PLAN COMMISSION

September 26, 2023

PLAN COMMISSION REPORT

Proposal: Plan Review – Parking Lot Expansion

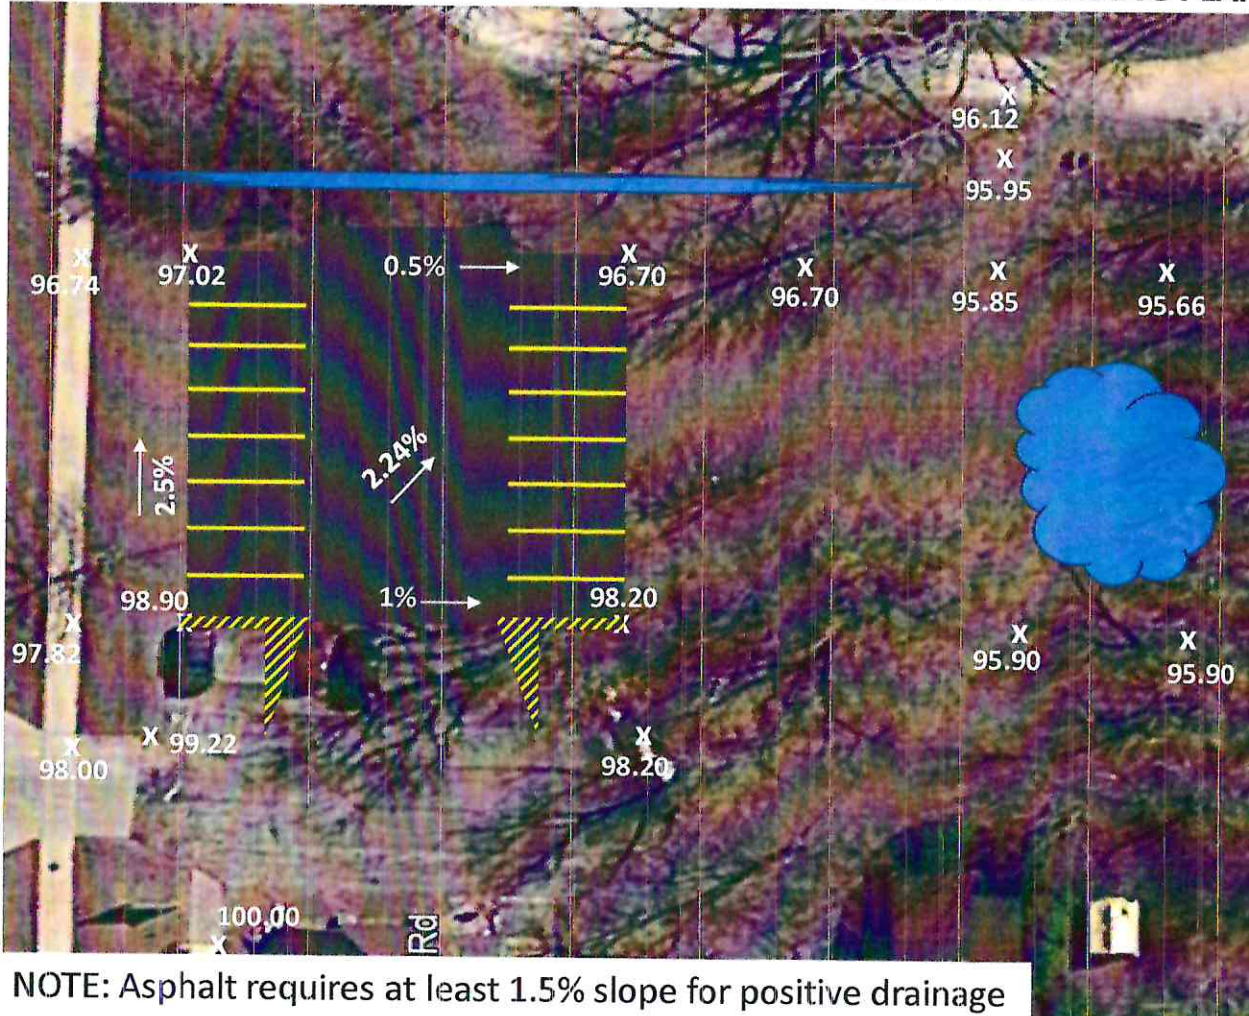
As proposed, the 24' wide drive aisle meets the dimensional standards per Sec. 15.0501(d). Parking stall widths are shown as 9' and 10' which meets Code. The plans are missing dimensions showing the length of parking stalls—for 90° parking stalls, a minimum length of 18' is required. Plans should be revised to show this dimension.

Submitted plans are missing some required elements for approval, including a landscape plan. The submitted plan shows the parking lot extension with an 18' setback, which allows space for the required 15' parking lot perimeter landscaping. For approval, a landscape plan must meet the standards of Sec. 17.0505 (1) and (2) showing both parking lot perimeter area and parking lot interior area. The proposed parking lot layout does not include areas for required landscape islands; staff has provided a suggested configuration that includes the same number of parking spaces with landscape islands shown. This concept is just an example that would meet Code and revised plans could use an alternate configuration that meets Code requirements.

PROPOSED GRADING PLAN

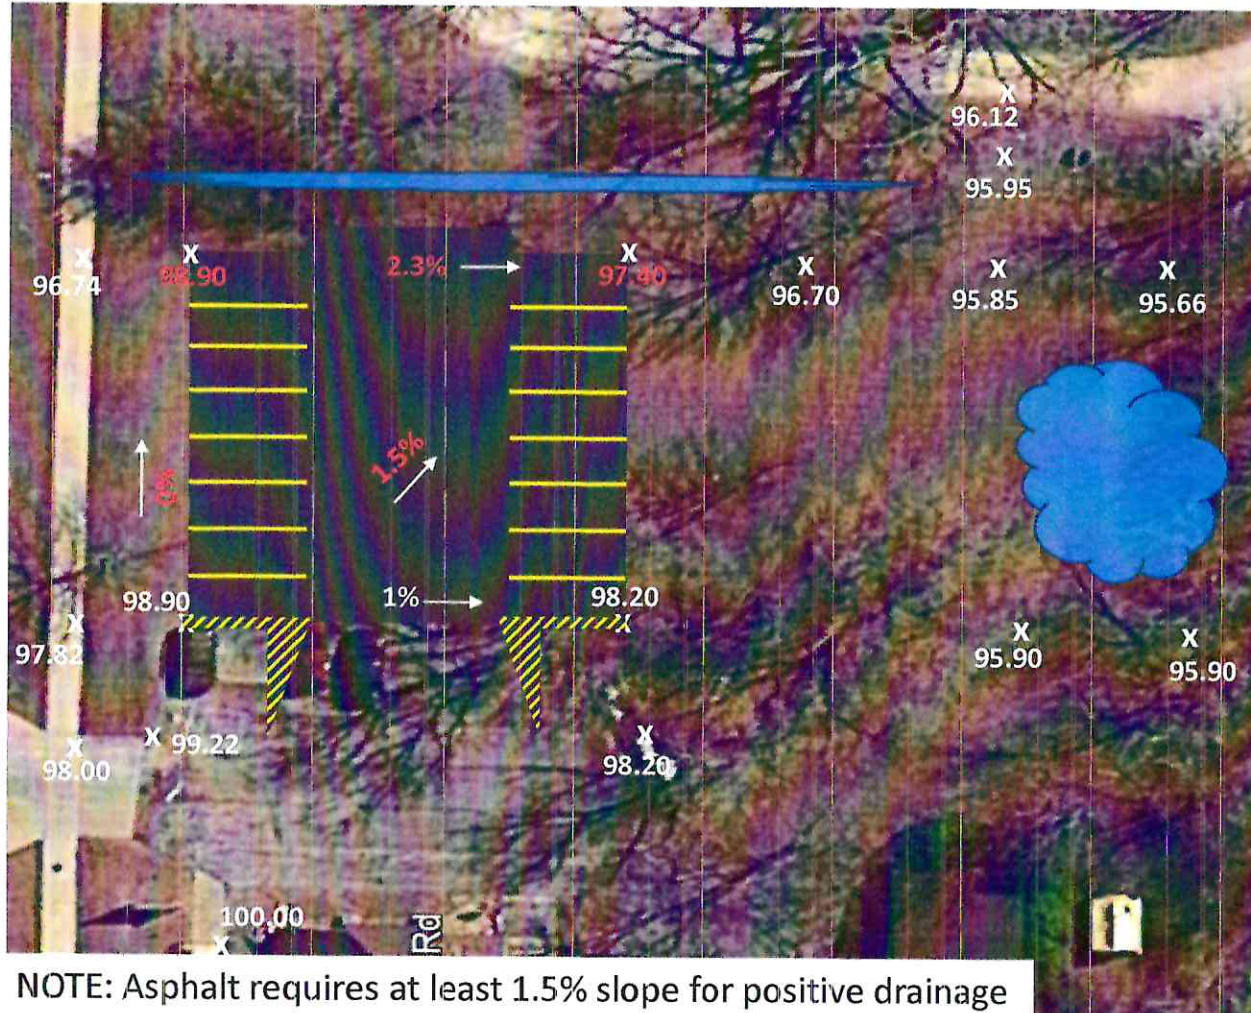
Grading plans showing existing and proposed elevations, slopes, and drainage have also not been received; the Applicant should coordinate with the Engineering Department on approval for a grading plan.

1. That all relevant Code requirements remain in effect.
2. That plans are revised to show parking stall lengths that meet Code.
3. That the landscape plan is revised to show plant height at installation, with a minimum height of 3 feet.
4. That all revised plans (site, grading, landscaping, etc.) are submitted in digital format for review by the Department of Community Development prior to the submission of building permit applications.

Plan View
Scale = 1" = 10ft

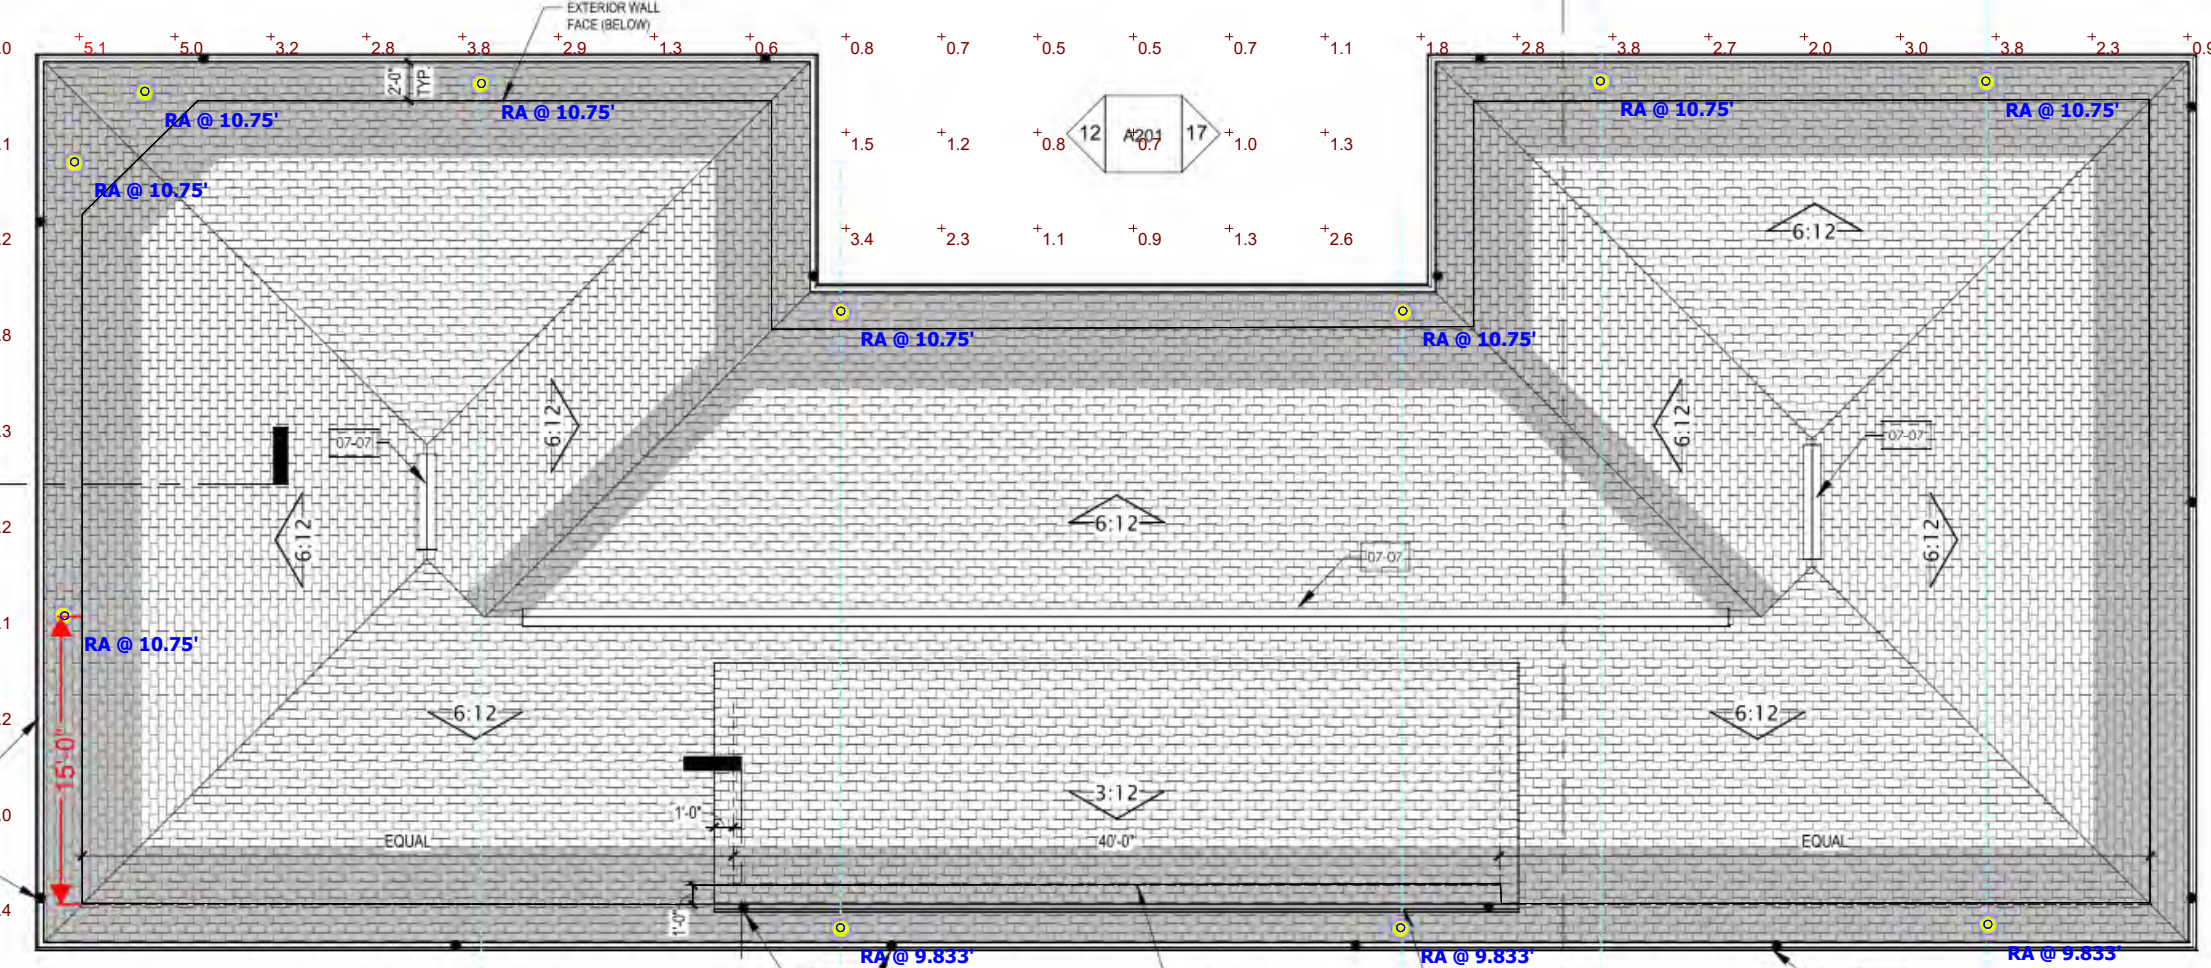
Lighting plans and fixture cut sheets have been provided for the building only, consisting of "wafer" downlights under the roofline. Per Code, all fixtures except architectural accent wash lighting shall have a color temperature less than or equal to 5,000 Kelvins. Based on the submissions, it appears that the proposed lights meet all Code requirements.
